CNL-16-039

Watts Bar Nuclear Plant, Unit 1
Facility Operating License No. NPF-90
NRC Docket No. 50-390

Subject: **Application to Modify Watts Bar Nuclear Plant Unit 1 Technical Specifications Regarding Use of Component Cooling System (CCS) Pump 2B-B to Support CCS Train B Operability (WBN-TS-14-004)**

**Subject: Application to Modify Watts Bar Nuclear Plant, Unit 1 Technical Specifications
Regarding Use of Component Cooling System (CCS) Pump 2B-B to Support
CCS Train B Operability (WBN TS 14-004)**

**Simplified Component Cooling System
Normal Lineup**

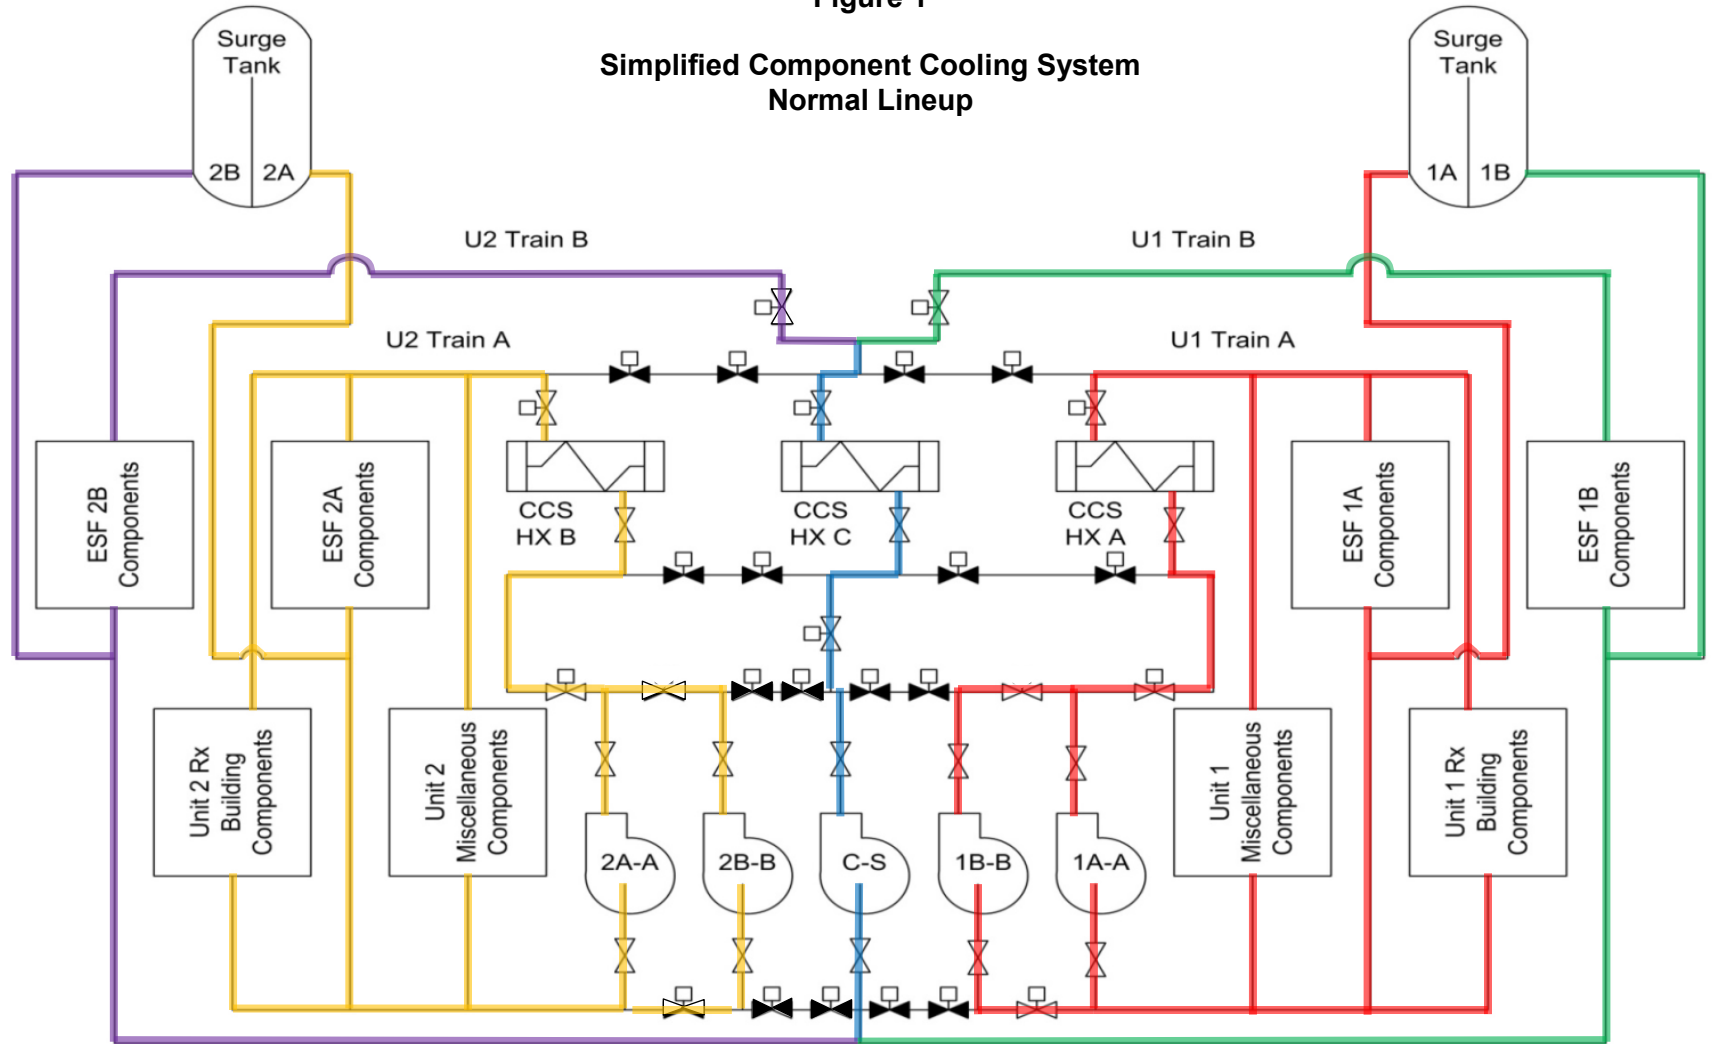
During full power operation, with all CCS equipment available (refer to Figure 1), CCS pumps 1A-A and 1B-B and HX A are aligned with Unit 1, Train 1A ESF and miscellaneous equipment. CCS pumps 2A-A and 2B-B and HX B are aligned with Unit 2 Train 2A ESF and miscellaneous equipment. CCS pump C-S and HX C are aligned with both Unit 1, Train 1B and Unit 2, Train 2B. CCS pump 1B-B can be used as additional capacity for Train 1A and as a replacement for pump C-S, if it should be out of service. Pump 2B-B is used as additional capacity for Train 2A or as a replacement for CCS pump C-S, if it should be out of service.

**Simplified Component Cooling System
CCS Pump 2B-B Supplying Trains 1B and 2B**

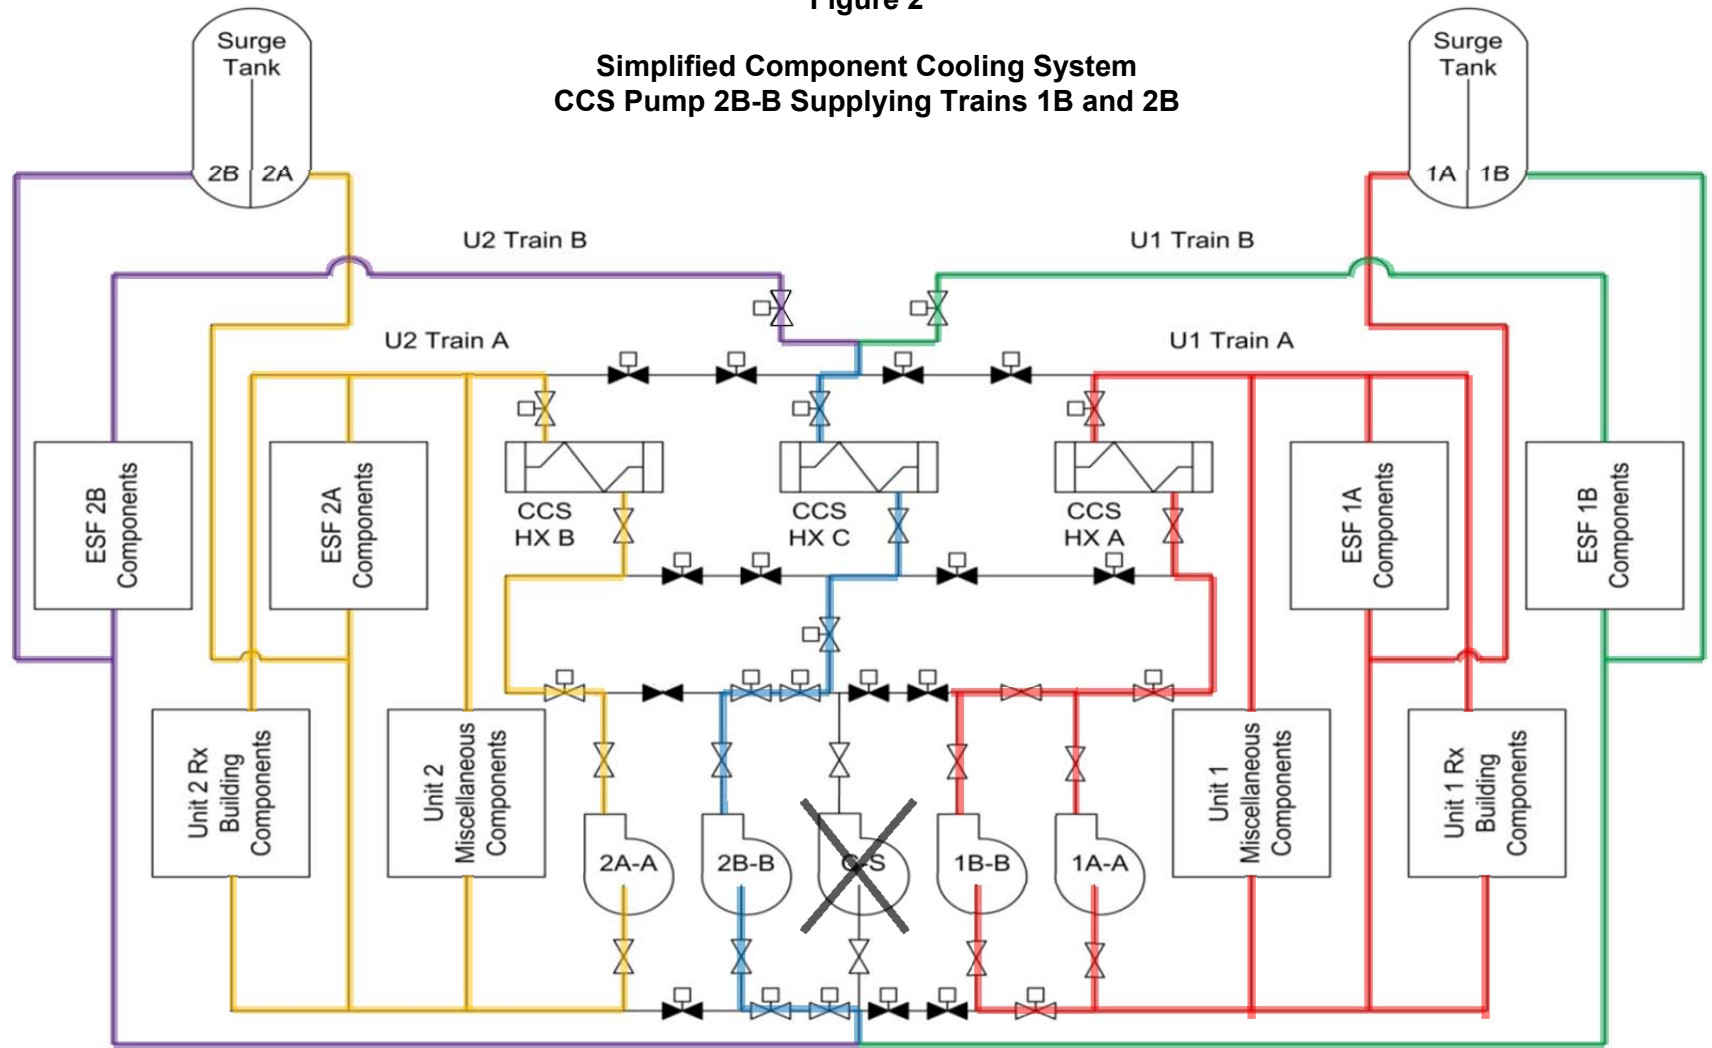
During full power operation, with the C-S pump out-of-service using CCS pump 2B-B for Train B (refer to Figure 2), pumps 1A-A and 1B-B and HX A are aligned with Unit 1, Train 1A ESF. CCS pumps 2A-A and HX B are aligned with Unit 2, Train 2A ESF. CCS pump 2B-B and HX C are aligned with both Unit 1, Train 1B and Unit 2, Train 2B. CCS pump 1B-B can be used as additional capacity for Train 1A, as required.
